MAINE TURNPIKE AUTHORITY

ADDENDUM NO. 1

CONTRACT 2015.10

LUNT'S HILL ROAD UNDERPASS BRIDGE (MM 99.0)

**ASPHALTIC PLUG JOINT DETAIL**  
Scale: 1/2" = 1'-0"

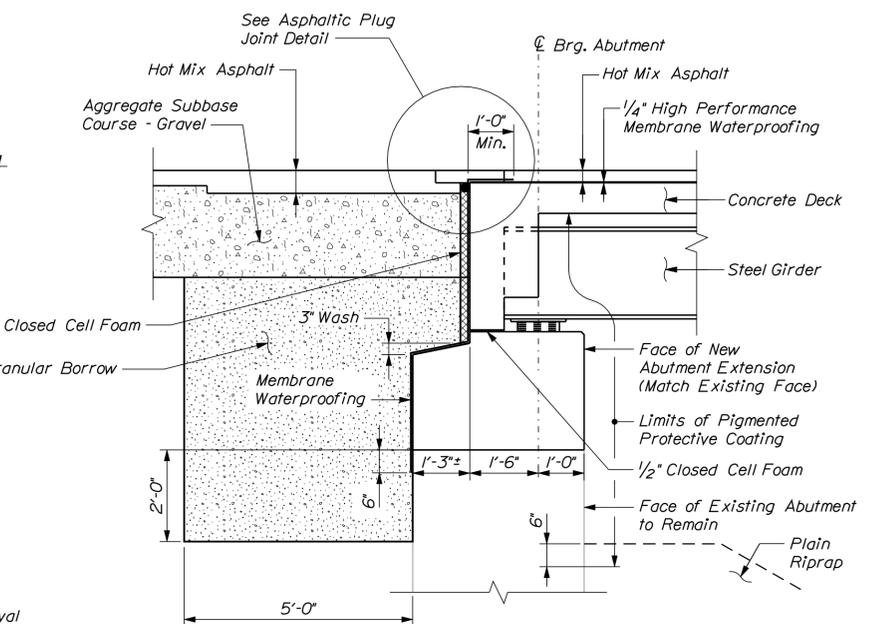
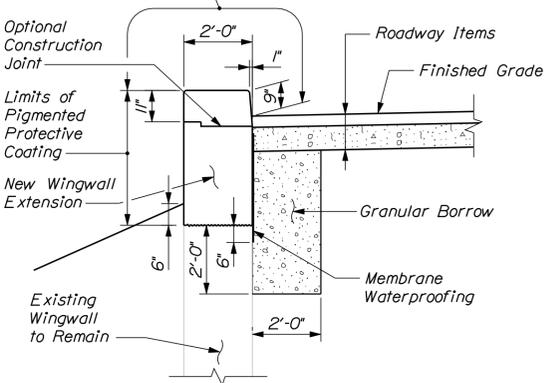
- 6) Question: It is typically difficult to properly seat the Bearing Plate in the Asphaltic Plug Joint on pavement and it may cause a future maintenance issue. Can the detail be modified to eliminate the Bearing Plate?  
*Response: See the revised plan sheet in Addendum 1 that shows the revised Asphaltic Plug Joint Detail, in which the Continuous Bearing Plate has been removed.*

BRIDGE RAIL DETAILS

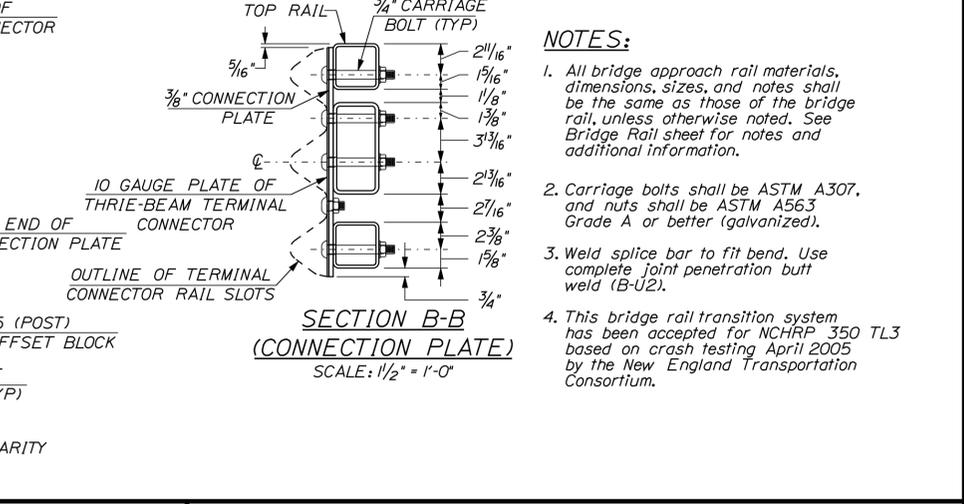
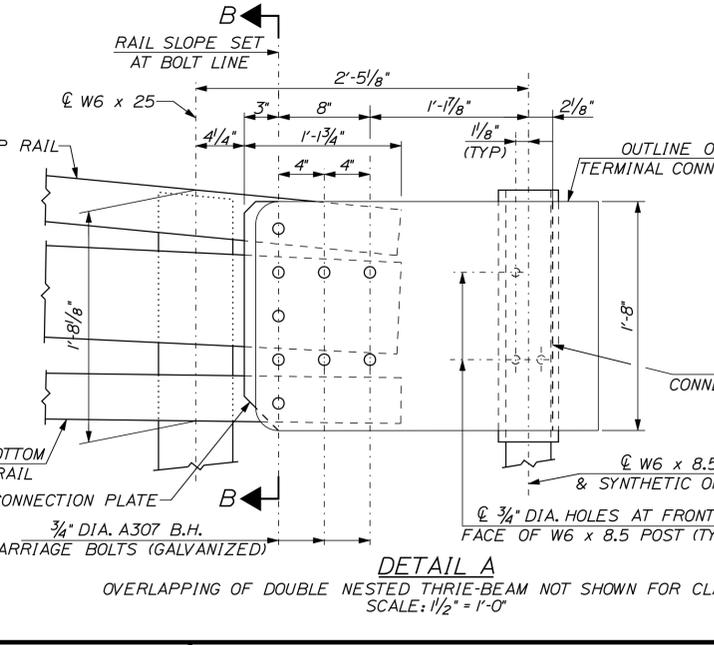
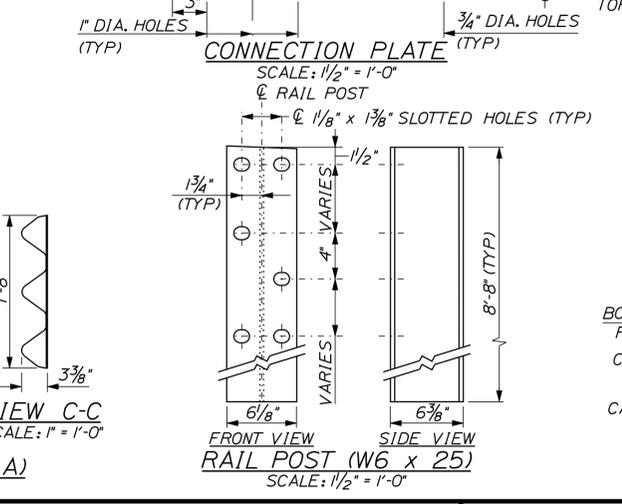
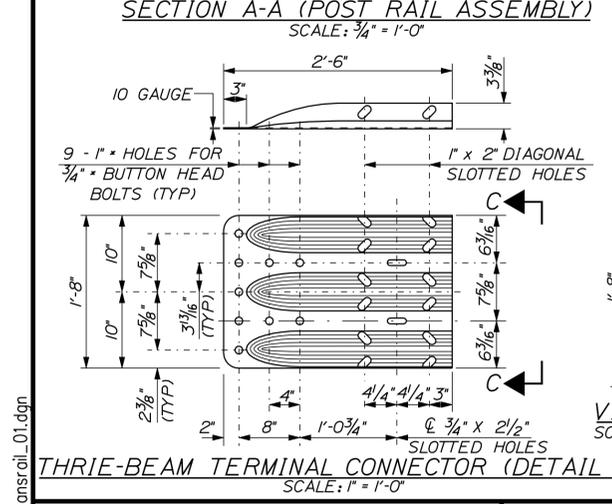
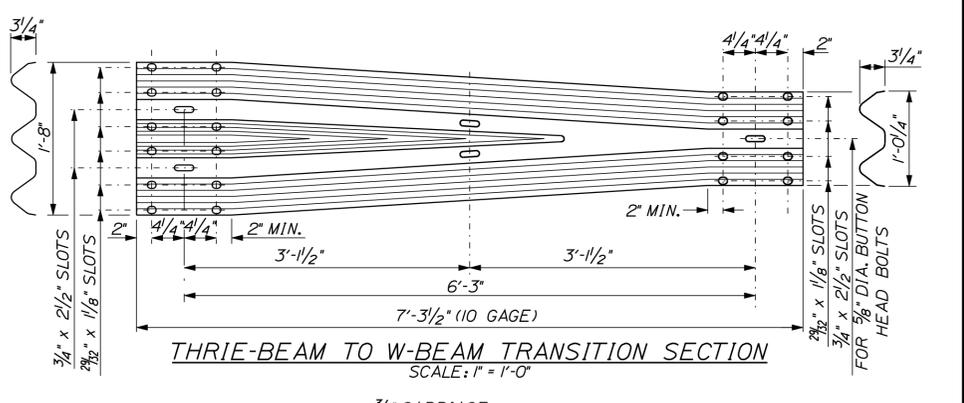
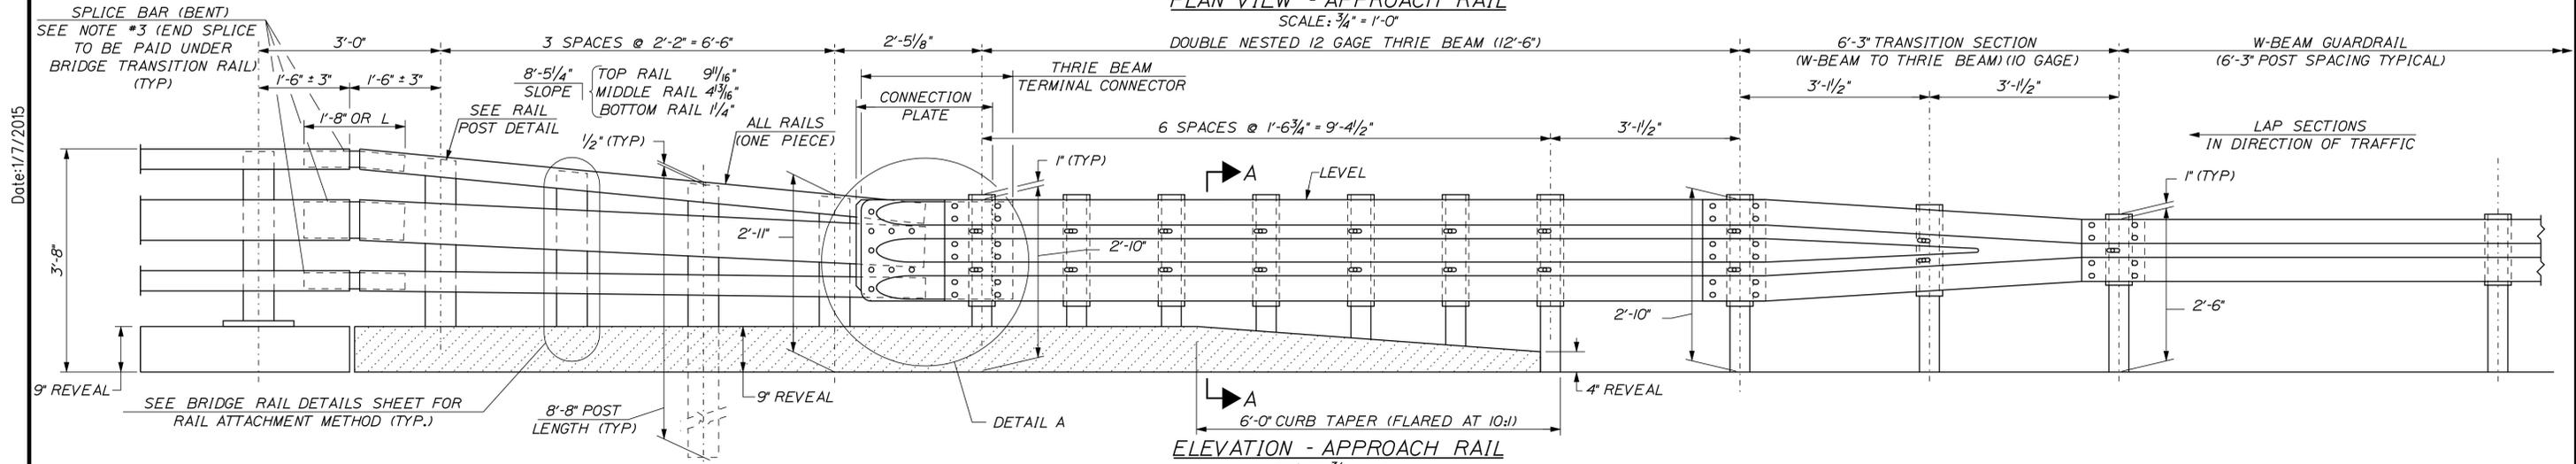
- 5) Question: Can the pay limits of the Steel Bridge Railing and Bridge Rail to W-Beam transition be revised? One fabricator will fabricate all parts made of tubular steel and a different fabricator will fabricate the thrie beam and w-beam sections.  
*Response: See the revised plan sheets in Addendum 1 that show the revised pay limits for Item 507.0821 – Steel Bridge Railing, 3 Bar and for Item 606.1728 – W-Beam to 3-Bar Bridge Rail Transition.*
